FORM P2A: FINAL SIGN-OFF FOR MASTER DEVELOPMENT PLANS AND SITE PLANS - EPC

**RE: Request for Major Amendment to a Prior Approved Site Plan – EPC
Amendment to the Plaza at Paseo del Norte Site Plan
Sedona West Apartments, Eagle Ranch Rd NW**

Project #2021-005442
SI-2021-00569 - Site Improvement
Major Amendment to Site Plan

EPC Conditions Response Letter

SHEET NO.
SDP1.1
 OF

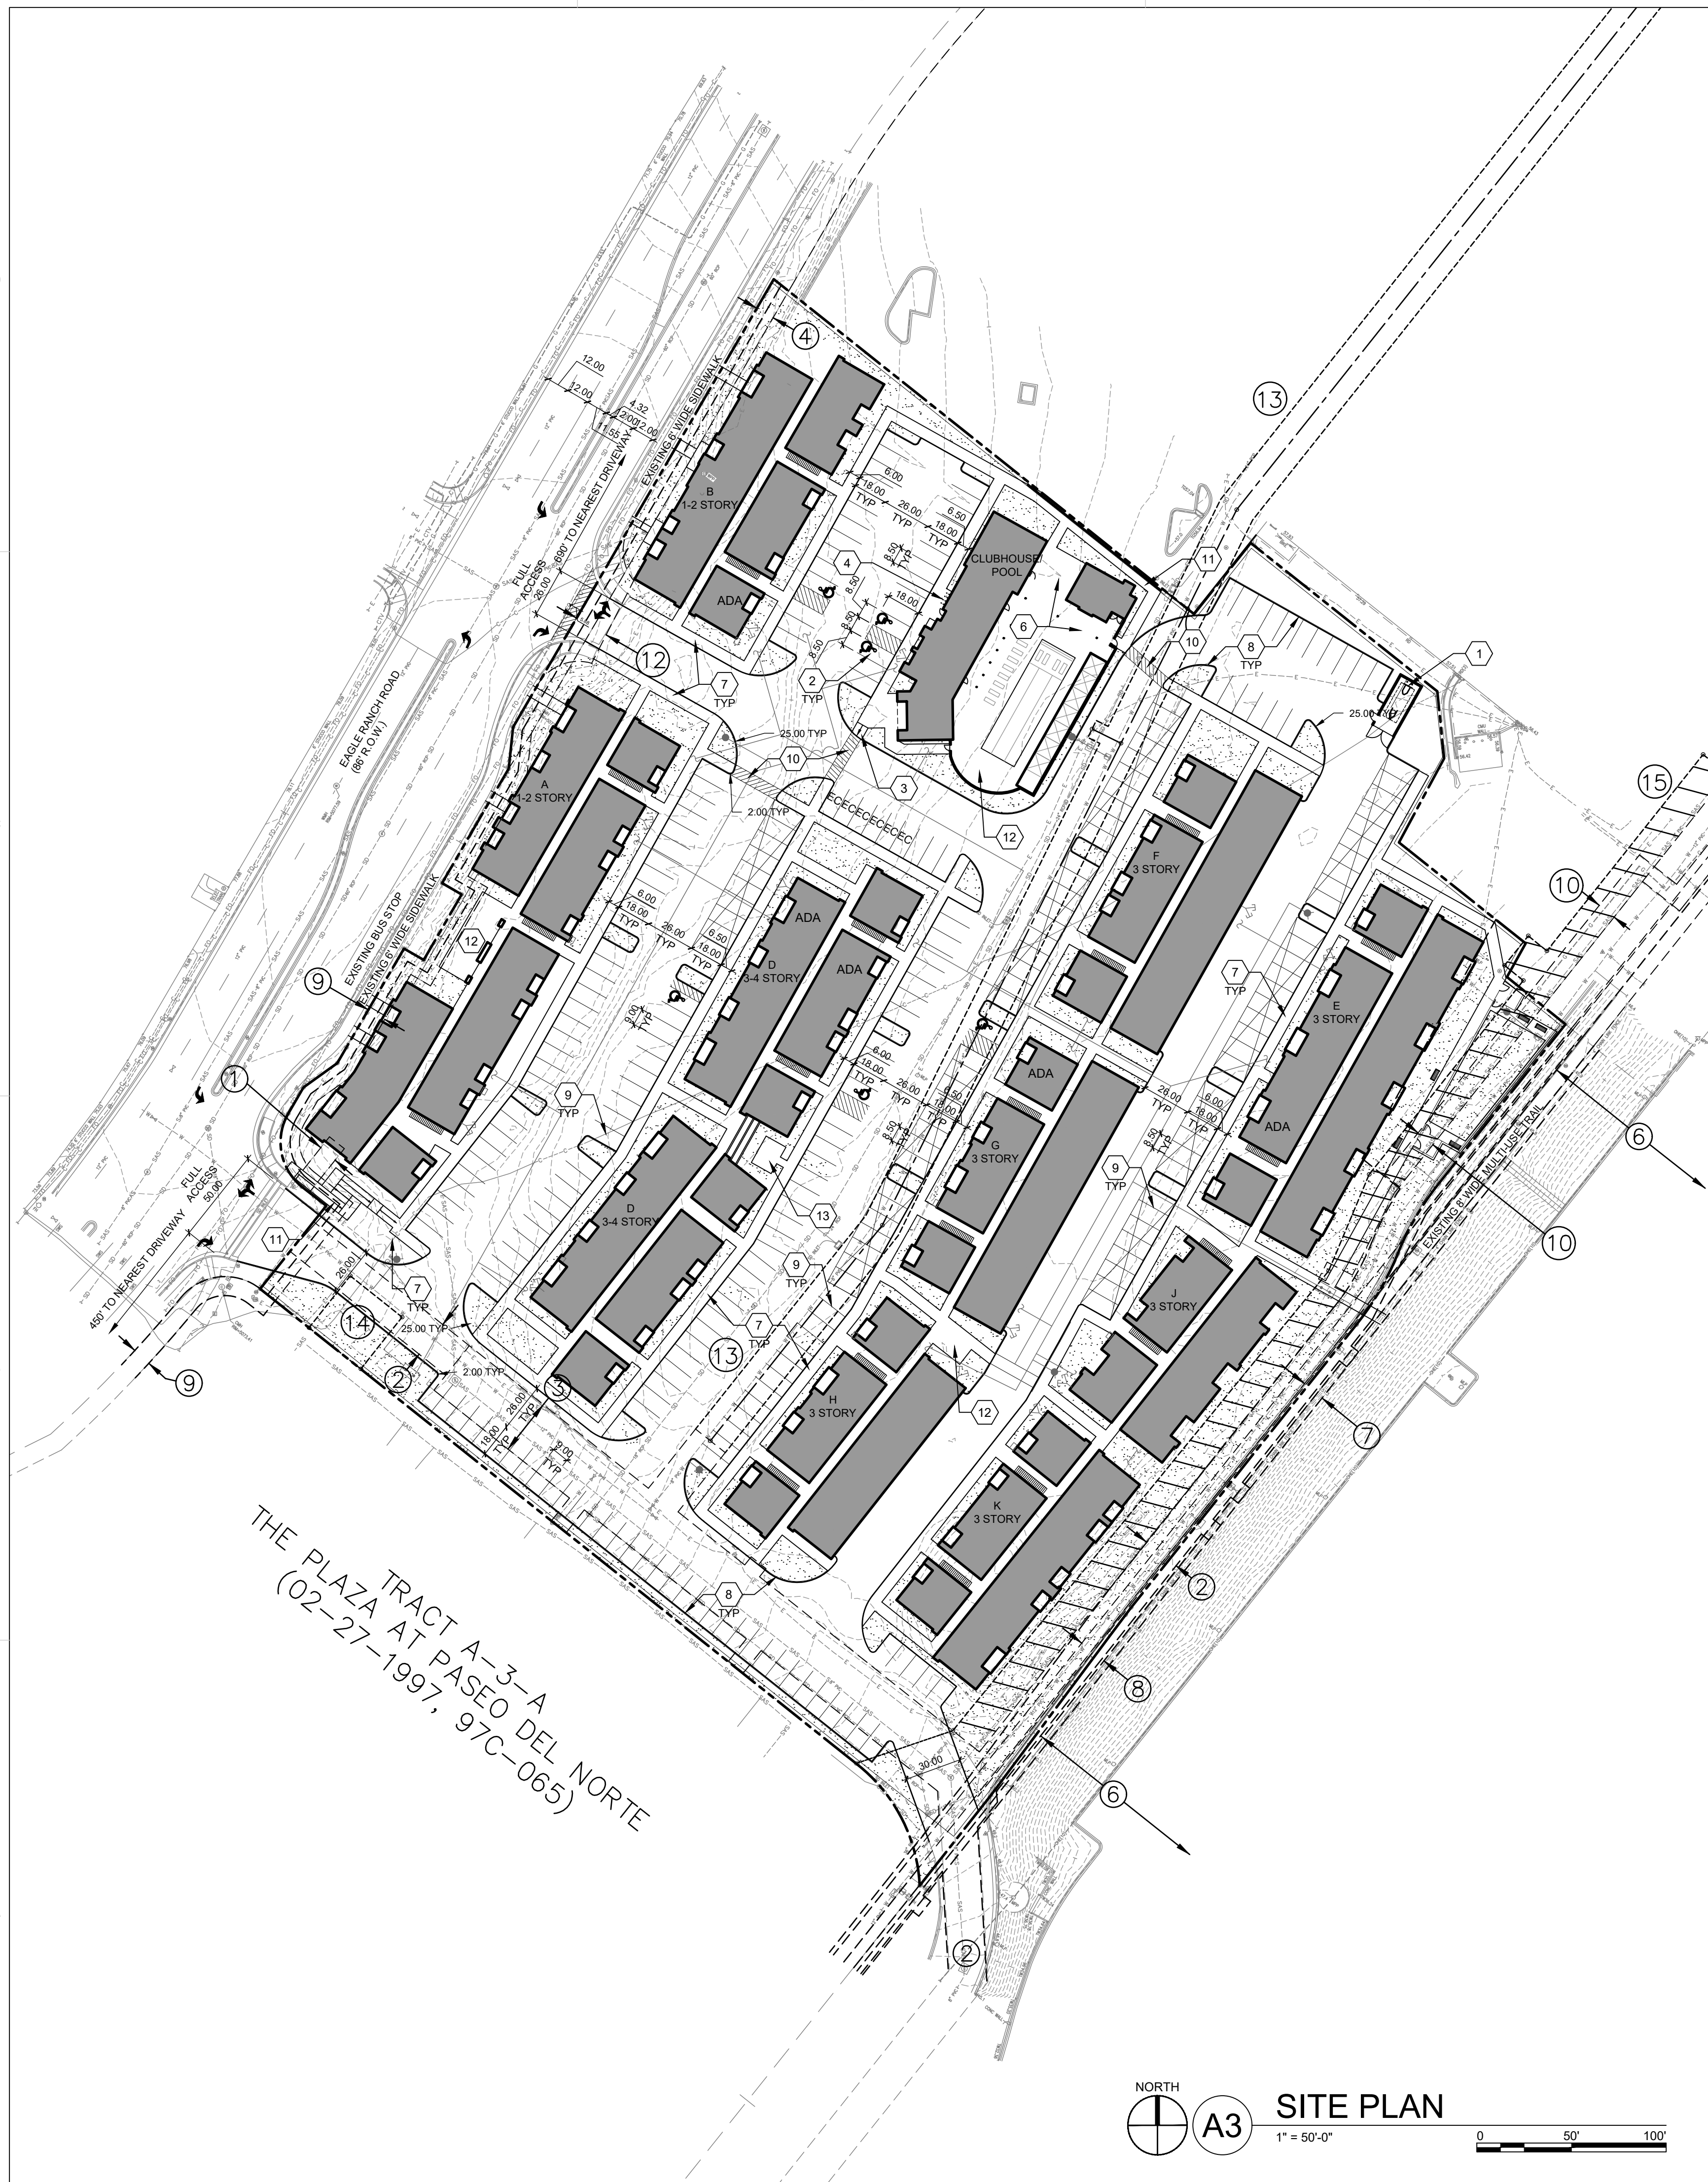
5. Outdoor Gathering Areas
 - a. Indicate where the proposed amenities will be located throughout the development.
 - i. **Response: Keyed notes have been added to the site plan locating the outdoor amenities.**

- a. **Response: The developers spoke with Parks and Recreation. It is agreed to repair the trail adjacent to this property as required. A keyed note has been added to the site plan.**
